Oifig na
nOibreacha Poiblí
Office of Public Works

ACP- PAX20.324167: Proposed Wind Farm Development in the townlands of Leggatinty, Carrigeenacreeha, Ballynahowna, Caranlea, Killummod, Culleenatreen or Flagford, Cartroncaran, Lodge, Carrigeen, Ballaghcullia, Ballindrehid, Corbally East, Peak, Gortnacloy, Tonaknick, Ballysundrivan, Caran, Cloonkerin, Carrowntogher, Corbally Middle, Ballyroddy, Cloonshanville, Skeanavart, Dacklin, Kinclare, Erriblagh, Lisgarve, Loughbally, Rathardeagher, Carrigeenynaghtan, Brackloon, Edenan and Kinclare, Kilnamryall, Corbally West, Cartronicarrarowntogher, Carrowncaran. County Roscommon.

This submission outlines observations from the OPW on this application by Carraigin Power Ltd, which is covered by the provisions of the Renewable Energy Directive III (Directive 2023/2413), for a proposed renewable energy development which will comprise 11 no. wind turbines, and associated infrastructure in the townland of

3.0 **OBSERVATION**

Fig. 1 View shed from Rathcroghan Mound. Image Credit: Dr Rory Connolly, Trinity College Dublin.

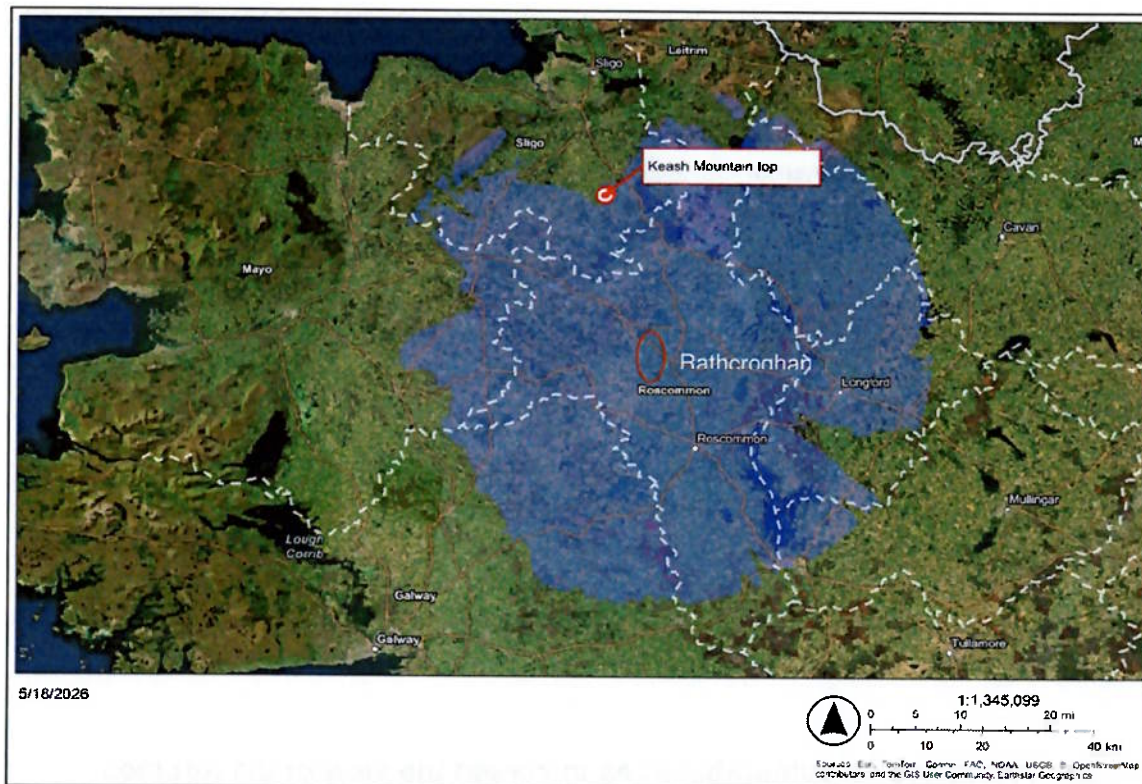
The viewshed analysis presented in Figure 1 was generated from a central observer point on Rathcroghan Mound, using an observer height of 6 feet, approximately 1.83 m, to represent the eye level of a standing adult.

The resulting model indicates areas of potential visibility from the mound (discounting vegetation), including the upland area of Keash/Keshcorran in Co. Sligo, marked here as 'Keash Mountain top'. This is a useful way of considering how Rathcroghan may have sat within a wider visual, mythological and remembered landscape (Figure 1). This visibility looking north is borne out by views experienced at Rathcroghan today where trees and other barriers are absent.

The HIA states: 'beyond supporting an appreciation of the complex's elevated landscape in outward views from the north, that the wider landscape of Rathcroghan plays a rather limited role in supporting potential OUV.' (5.1.7) the OPW responds that the views looking north beyond the proposed turbines are views of Keash/Kish and the Bricklieve Mountains, a landscape with intangible cultural heritage connections.

Fig. 4 Extract from *map.apple*, estimated to date from March 2025 with proposed Carrigeen turbine clusters west and east in red, locations of aerial views of forestry provided below at a greater scale, and the locations of four important cultural sites in the Rathcroghan complex

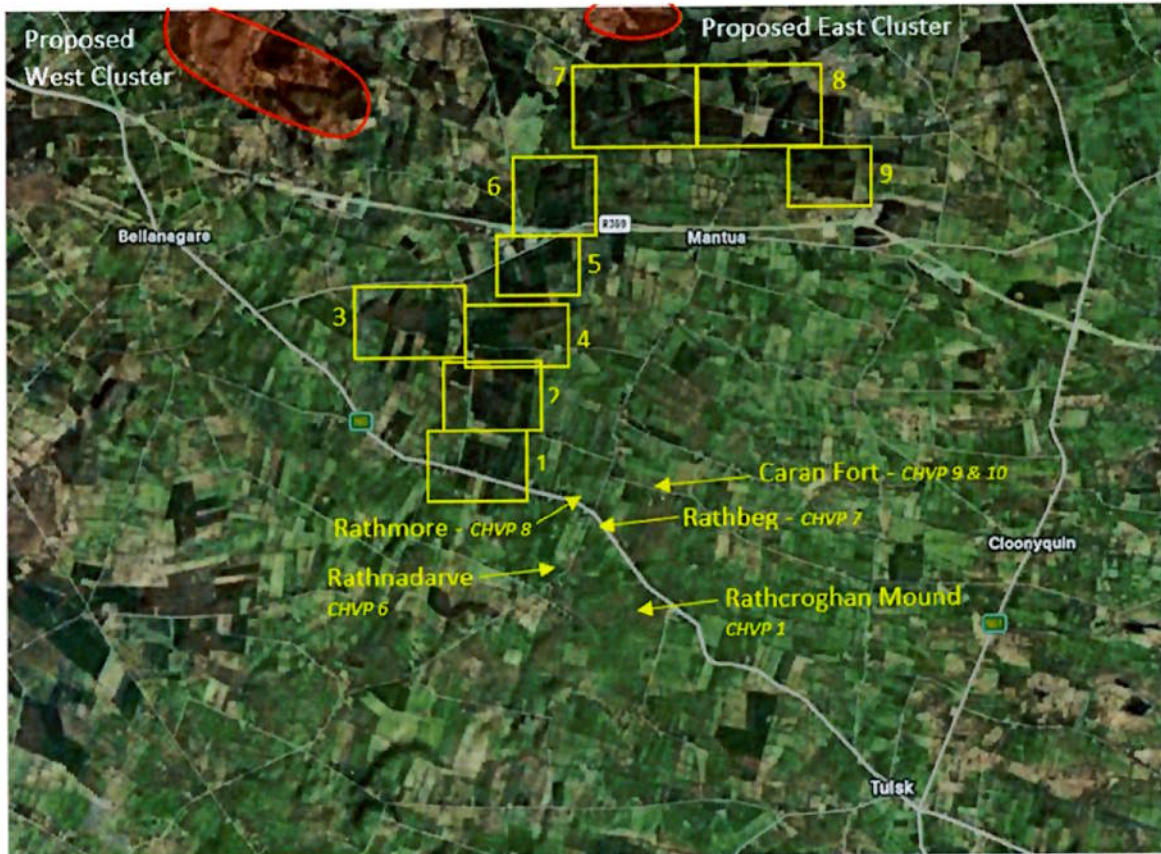
We refer ACP to the web based source material⁴, and for their convenience, Appendix 1, which contains nine close ups of the forestry as viewed from the air and referenced on the key map/aerial photograph. Figure 4 demonstrates how the screening afforded by the forestry (boxes 1-9) could, if of a similar longevity as the windfarm grant request (10 years planning permission, 35 years operation), be instrumental in the reduction of impacts on views from the Rathcroghan Plateau, and hence reduction of impact on cultural heritage. However, the above referenced aerial views depict extensive wind felling of these forestry plantations, which is not immediately apparent from the photomontages.

The OPW would argue that the commercial forestry, owned by others, cannot be considered a viable short-, medium- or long-term solution to screening of views of turbines from sensitive heritage receptors. The reasons include the normal harvesting of the commercial crop and the

The OPW asks that ACP request the applicant to provide an arboricultural and hedgerow study to ascertain the condition of and risks associated with commercial forestry, evergreen and

deciduous stands of trees and hedgerows. In addition, if it is technically feasible, we would ask ACP to request verifiable photomontages/visual impact studies adjusted for the loss of trees based on this proposed expert survey and on disclosed assumptions/scenarios.

Fig. 5 The application acknowledges that the windfarm is proposed on lands zoned 'less favoured' in relation to suitability for wind development. Ref. RCDP

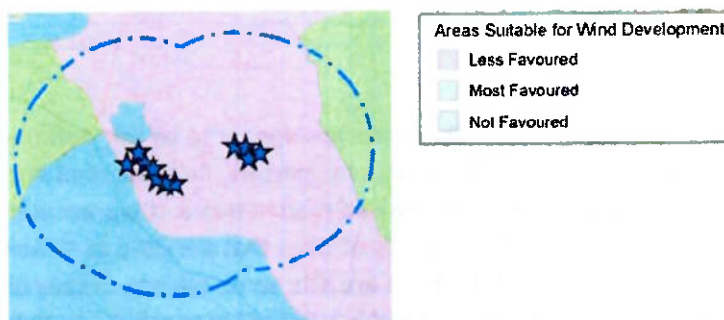
It is not clear how the LVIA chapter overlaps with the HIA. The LVIA establishes tiers of significance and sensitivity to change, e.g. it denotes as 'Very High': 'Areas where the landscape character exhibits a very low capacity for change in the form of development. Examples of which are high value landscapes, protected at an international or national level (World Heritage Site/National Park), where the principal management objectives are likely to be protection of the existing character.' As a proposed World Heritage Property (Tentative List, serial), this should put the Rathcroghan landscape in this category. However, the LVIA then places only Rathcroghan Mound in this category.

The OPW asks ACP to seek clarification in relation to the LVIA status with regard to Rathcroghan in the context of the HIA.

Fig. 14 CHVP 7a view from Rathbeg through mature trees around two privately owned dwellings

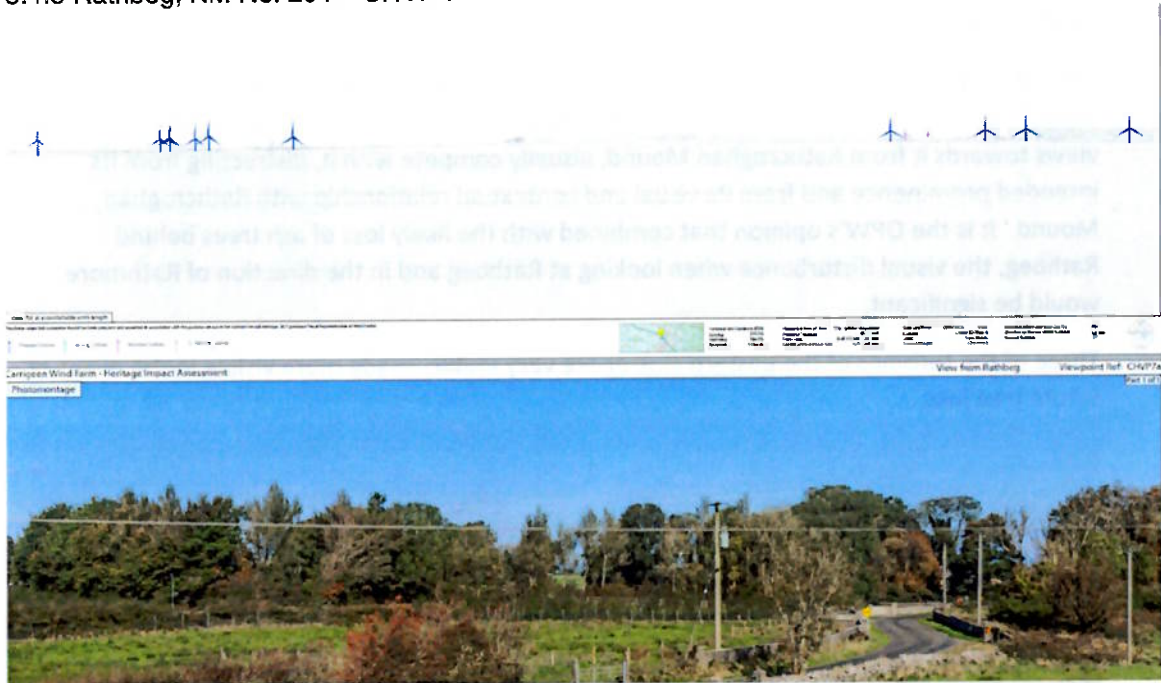
Above is the distant view from Rathbeg behind the trees, which appear to be mostly ash, in the mid-ground. The ash trees are visibly suffering from ash die back. It is anticipated that the view will open up in the near future as diseased trees are removed.

Fig. 20 View from Rathmore National Monument towards the east cluster with Knockaunstanley in the mid-ground, a dwelling and the remains of an earlier herdsman's hut

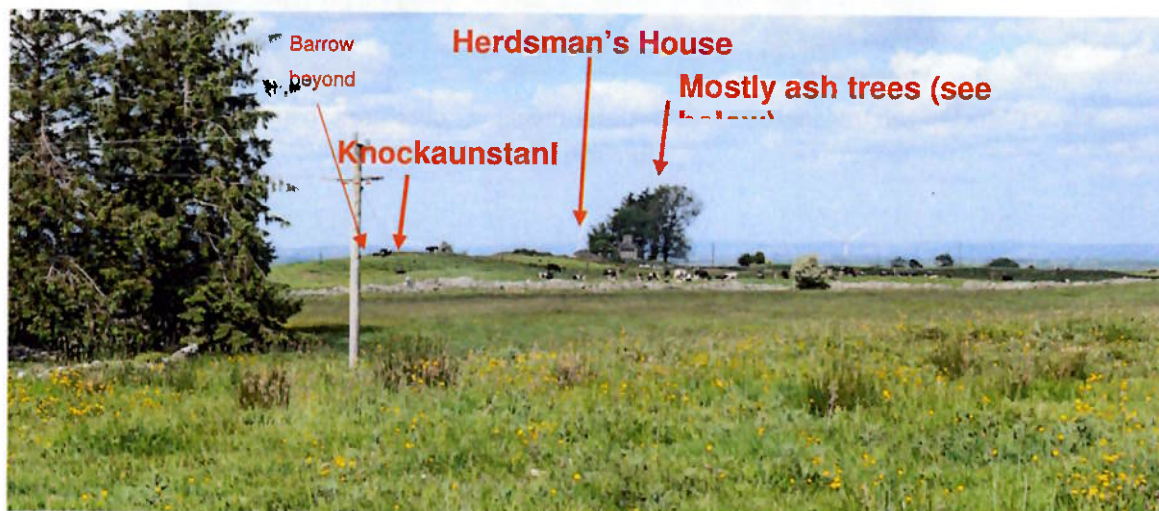
The ruins of a herdsman's cottage are located next to a later building. This cottage appears in the first edition ordnance survey map. At present, the trees screen the view of one of the turbines. The turbine if erected will be visible due to the loss of the ash trees to ash dieback.

Fig. 21 Most of the trees adjacent to the later dwelling house are ash and are visibly suffering from ash die-back.

Behind the 2-3 evergreen trees in the foreground, Keash and the Bricklieves in Sligo are revealed.

Fig 23 Wireframe of the 7no. turbines of the west cluster

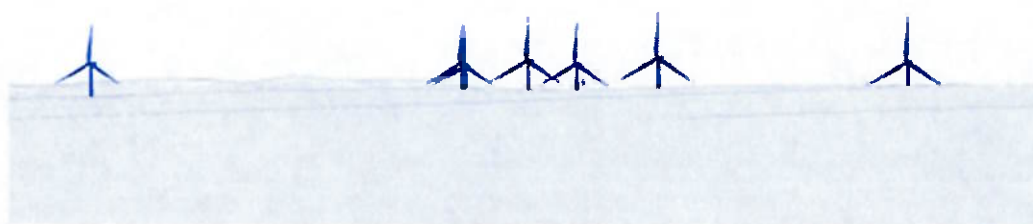
Fig. 24 View of the 7no. turbines of the west cluster partially screened by existing forestry

Fig. 25 Detail of the photomontage above revealing storm damage to the periphery trees

Based on the wind damage to the forestry plantation as visible from the air, it is anticipated that the forestry will be felled and all of the turbines will be visible. The wire model has not indicated the location of Rathcroghan Mound, however, the HIA states that it will not be noticeable in this view. The OPW is requesting that ACP ask the applicant to indicate the location of Rathcroghan Mound.

Fig. 26 Northern section of the RMP zone with CHVPs marked and SMRs from the application

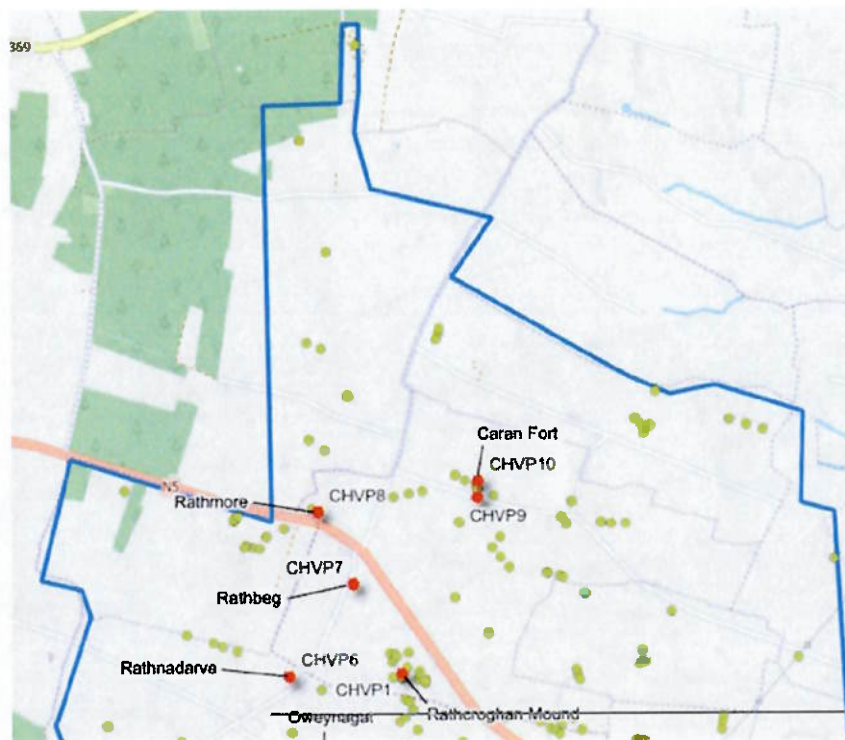
The OPW notes that this landscape is a continuous cultural landscape, and not a series of culturally significant points in a void. The Rathcroghan Plateau extends beyond the chosen Viewpoint locations. The northern edge of the RMP zone (blue) is close to the edge of the plateau.

In addition to archaeological sites contained within the RMP boundary and north of Caran Fort, there may be other monuments identified in defining the OUV, attributes and the WHP boundary for this component site. The HIA has not provided a rationale for the selection or omission of views.

Fig. 27 Screenshot from archaeology.ie with terrain map. This shows the extent of the plateau as it falls to the north and the distribution of archaeological sites.

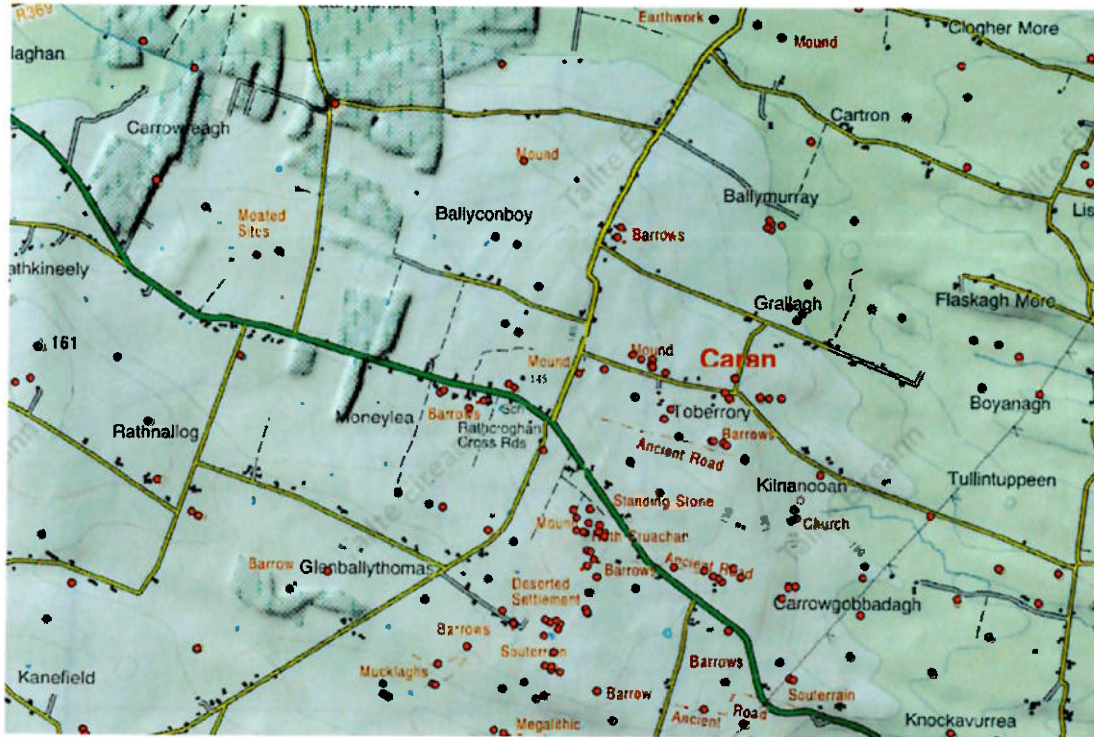
Headland Archaeology noted that the use of the RMP boundary as a proxy due to the lack of definition of the OUV, WHP and buffer zone. Other National Monuments in state care located at the north of the plateau are: Toberrory Fort, Rathscrag Fort and Courtmoyle. The HIA has noted the relatively open views to the north towards Sligo. The loss of some of the commercial forestry would open the view towards Keash.
